SOUTH CAROLINA ELECTRIC & GAS COMPANY

July 6, 1981

Subject: V. C. Summer Nuclear Station
Docket No. 50/395
Technical Specifications

Attached is our proposed revision to your latest draft (March 10, 1981) of the Technical Specifications for the V. C. Summer Nuclear Station. Most of the changes are to the environmental part of the Specifications and are necessary to apply to our plant design. Explanation for each change is as follows:

FIGURE 6.2-2
V.C. SUMMER NUCLEAR STATION
FUNCTIONAL ORGANIZATION

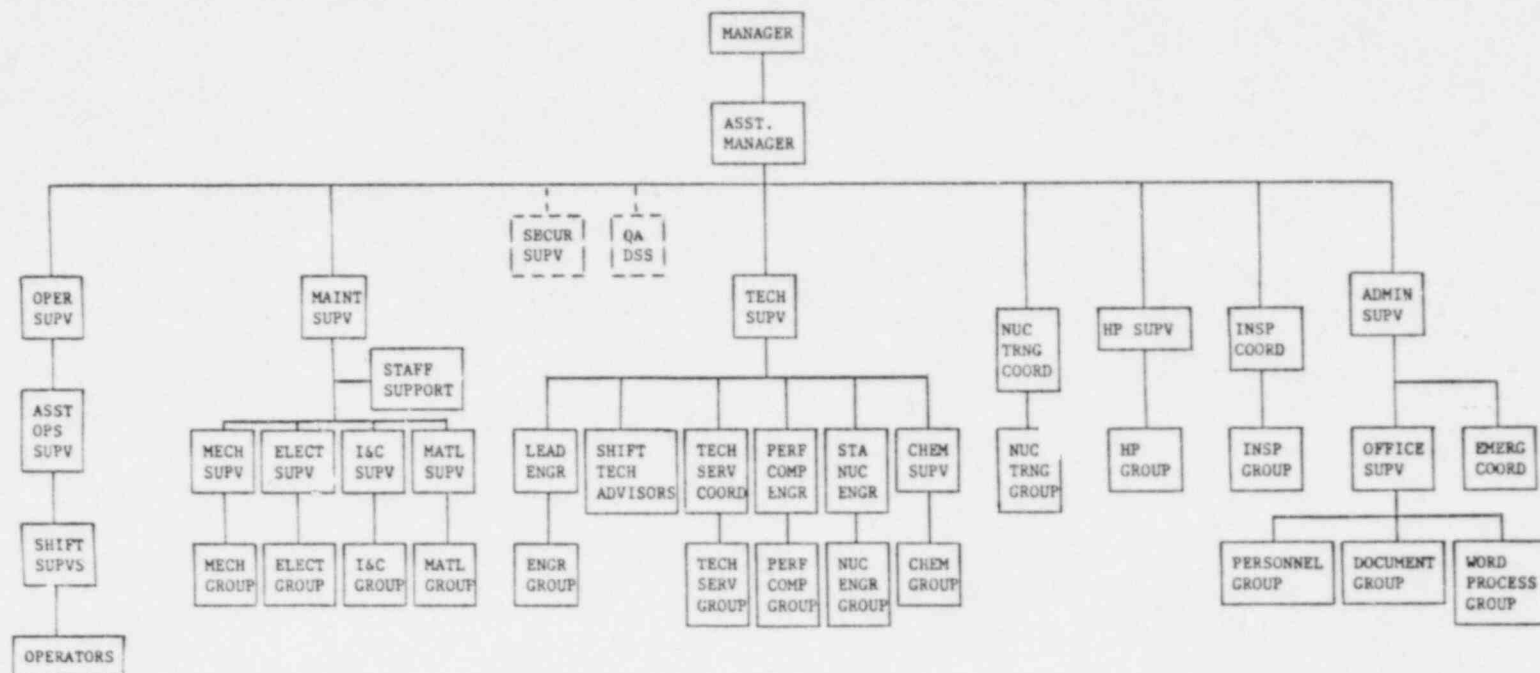
- 3/4 12-3 These changes update this table to the current
thru 12-12 environmental monitoring program.
- B 3/4 11-2 See Explanation for 3/4 11-8.
& 11-3
- 5-1 The reactor building is a prestressed-posttensioned
reinforced concrete structure.
- Figure 5.1-4 Mispelled.
- 6-3 New plant organization chart to reflect recent
changes. The major changes are that now the
Health Physics Supervisor, QC Inspection Coordinator,
and the Nuclear Training Coordinator report directly
to plant management.
